Customer: W. B. Howland Company, Inc.	Job Number: Repair 18-1977
Job Description: 18-1977-C5/REPAIR	
Address:	City, State, Zip:

Job Number: Repair 18-1977
18-1977-C5/REPAIR
Truss Label: C5 rep

Truss repaired to modify the BC profile as shown.

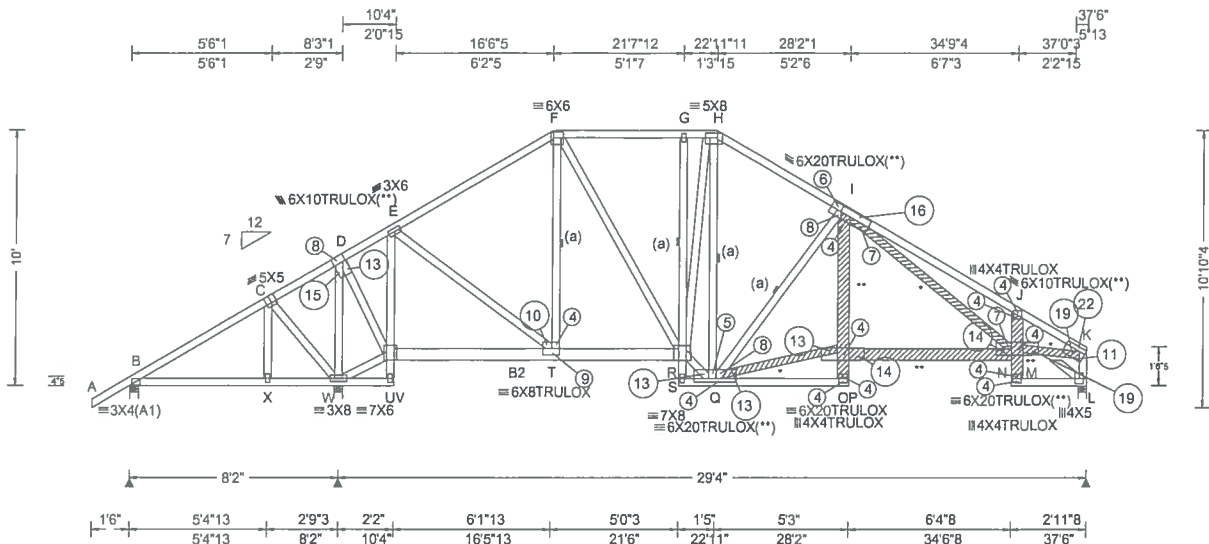
* (3)NEW 2x4 SP #2-13B (OR BETTER) MEMBERS.
** (3)NEW 2x6 SP #2-13B (OR BETTER) MEMBERS.
CUT TO FIT AS SHOWN WITH HATCHED MEMBER BELOW.
(+)REMOVE EXISTING MEMBER AND REPLACE WITH *, and **.

+ USE A SHARP METAL CUTTING SAW BLADE TO CAREFULLY REMOVE MATERIAL FROM THE TRUSS AS SHOWN. REMAINING PORTIONS OF TRUSS AND ALPINE PLATES MUST BE FREE FROM DAMAGE.
